Wabush Service Upgrade – Wabush Airport, NL

EC373-230778/A

AMENDMENT # 3

ADDENDUM NO. 2

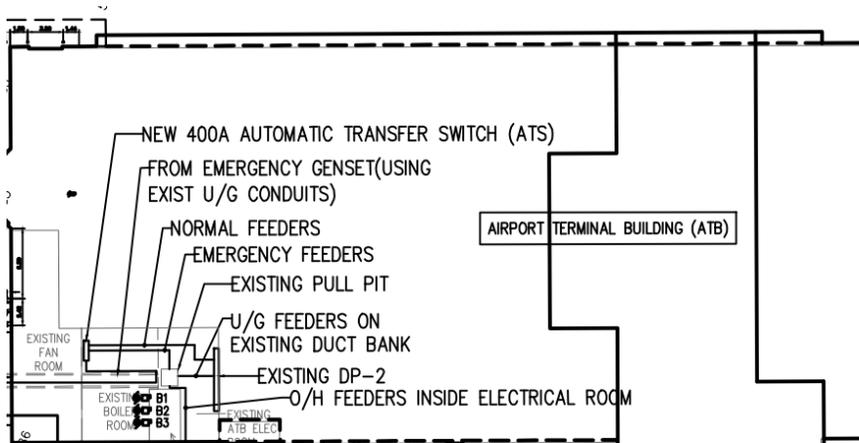
Question # 7: Please confirm if conduit between new load bank and building will be direct buried or concrete encased?
Also, can you please provide wires size between the load bank and CSB panel?

Answer # 7: New conduit to be concrete encased. Revise breaker connected to load bank from 300 A to 400 A.
3C-500MCM+G Teck90 Cu in duct bank as per Diagram D-11/Detail 1/Table D-11A. New CDP main breaker to be revised to new 400A-3P.

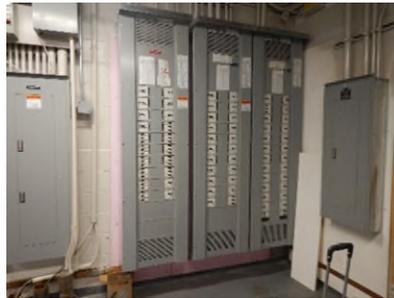
Question # 12: Can you please specify the dimensions of pullpit to be provided between New Switchgear 15KV switchgear and existing manhole

Answer #12: Refer to Dwg E-3/Detail 6 for typical layout and associated specs. 6/E3 note 2 to be revised to read "TYPICAL DIMENSIONS 1820mm(DEPTH) X 3350mm(WIDTH)X 2230mm(HEIGHT)". Structural design to be provided by civil/structural engineer. Submit shop drawings for approval before placing order.
